# Access Compliance Report

## Public Rights-of-Way

### (Curb Ramps)

Intersection ID: 8009	Main Street: GOSSETT_AV	Cross Street: RIDGELEY_DR	Location:	N
ADA ID: EA3A7C4B52D3	Ramp Type: BlendTrans2	Initial Pass/Fail: Fail	Overall Compliance: No	Severity Score: 10
Codes/Mitigation Info/Possible Solution		Field Measurements/Component Compliance

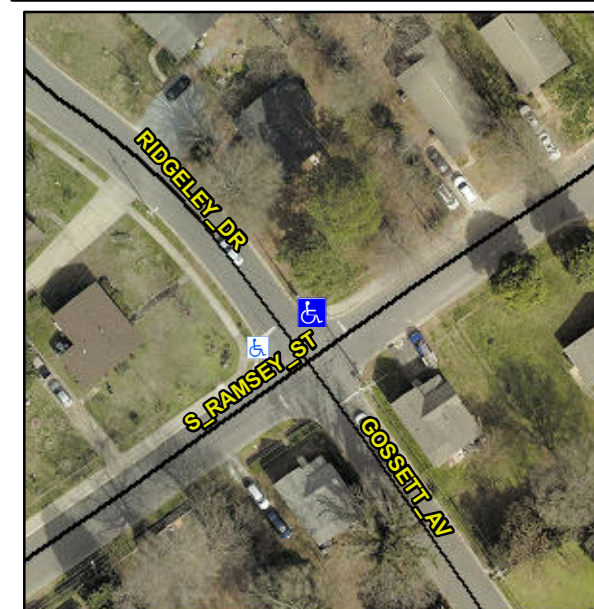
**NO LT SW**

**Not Found, R304.5.1, R304.5.3**

Compliance	Description	Data	Compliance	Description	Data
N/A	Ramp Length (in)	71.0	Yes	BlendTrans Slope (%)	4.4
No	Ramp Width (in)	47.5	No	BlendTrans XSlope (%)	2.1
N/A	Flare Type LT	N/A	N/A	Flare Type RT	N/A
N/A	Flare Slope LT (%)	N/A	N/A	Flare Slope RT (%)	N/A
N/A	Flare Traversable LT?	N/A	N/A	Flare Traversable RT?	N/A
N/A	Landing Length (in)	N/A	N/A	DWS Provided?	N/A
N/A	Landing Width (in)	N/A	N/A	DWS Contrast?	N/A
N/A	Landing Slope (%)	N/A	N/A	DWS Length (in)	N/A
N/A	Landing X Slope (%)	N/A	N/A	DWS Full Width?	N/A
N/A	Landing Curb? (Y/N)	N/A	N/A	DWS Offset (in)	N/A
N/A	Shared Landing?	N/A			
N/A	Gutter Ponding?	N/A	N/A	Gutter Slope (%)	N/A
N/A	Gutter Lip Ht (in)	N/A	N/A	Gutter X Slope (%)	N/A
N/A	Painted X Walk1?	No	N/A	Painted X Walk2?	N/A
	X Walk 1 Direction	To SW		X Walk 2 Direction	N/A
	X Walk 1 Width (in)	N/A		X Walk 2 Width (in)	N/A
	X Walk 1 Slope (%)	6.9		X Walk 2 Slope (%)	N/A
	X Walk 1 X Slope (%)	1.6		X Walk 2 X Slope (%)	N/A

N/A	Ramp inside XWalk1?	N/A	N/A	Ramp inside XWalk2?	N/A
	Road Slope (%)	1.6		Clear Space?	N/A
	Road X Slope (%)	6.9	N/A	Clear Space to XWalk (in)	N/A
N/A	Any Obstructions?	N/A	N/A	Storm Grate/Utility Hazard?	N/A
	Obstruction Type			Storm Grate/Utility Type	
		N/A			N/A
			Yes	Surface Condition? (G/P)	Good
			No	Curb Slope (%)	14.3

**Remove & Replace Curb Ramp With Two New Directional Ramps or Equivalent.**
